VENDOR FIELD SERVICE BULLETIN
Effective Date: 09/05/2001

Landing/Taxi Light Assembly
P/N: 01-0790131-06 (Right-side Assembly)
P/N: 01-0790131-05 (Left-side Assembly)

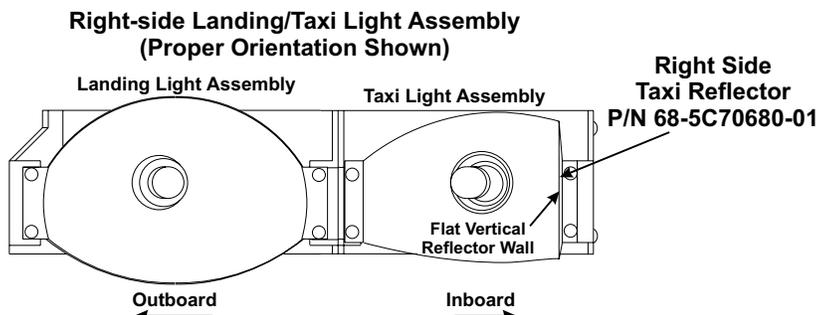
Beginning with the Landing/Taxi light assembly mounted on the Left wing, visually inspect the inboard (Taxi) reflector. Note that this reflector should be oriented as shown, with the flat vertical reflector wall located in the inboard position.

When inspection of the left Landing/Taxi light assembly is completed, proceed to the right Landing/Taxi light assembly. As shown, the flat vertical reflector wall should be oriented so that it is in the inboard position.

If both the left and right light assemblies are improperly oriented, the taxi reflectors may be removed from their present location and installed on the opposite wing's light assembly. In these cases, no additional reflectors will be needed.

If a single light assembly is improperly oriented, the correct reflector must be installed and the original reflector returned to:

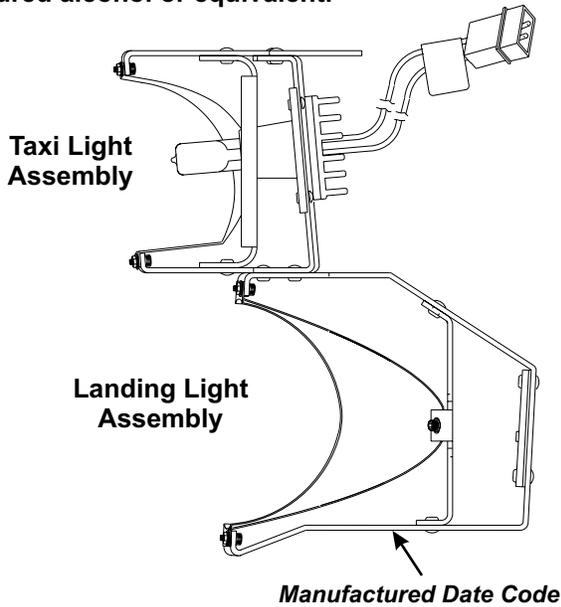
Step 1 - Orient the assembly as shown. Rotate the lamp assembly in a counter-clockwise direction. **DO NOT TOUCH THE BULB'S GLASS ENVELOPE WITH BARE HANDS!** Carefully remove the lamp assembly.

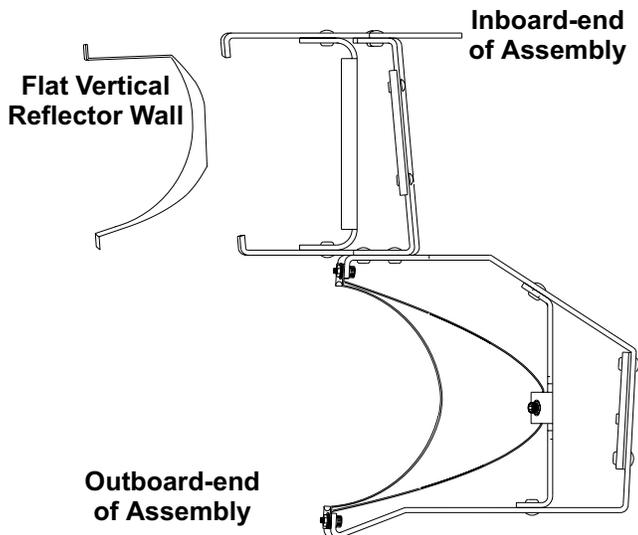
Step 2 - Locate, remove and retain the four (4) nuts, flat washers and socket head bolts that secure the taxi reflector to the assembly. Remove the taxi reflector from the assembly.

Step 3 - Obtain the correct reflector for the taxi light. When properly oriented, the flat vertical reflector wall will be positioned at the inboard end of the assembly and the lamp opening will be aligned with the lamp mounting opening in the assembly.

Step 4 - Position the new reflector onto the assembly and secure with the original hardware. Wipe the mirrored surface of the installed reflector with a clean soft lint-free cloth to remove any fingerprints or contaminants. Re-install the light removed in step 1. Re-install completed assembly .
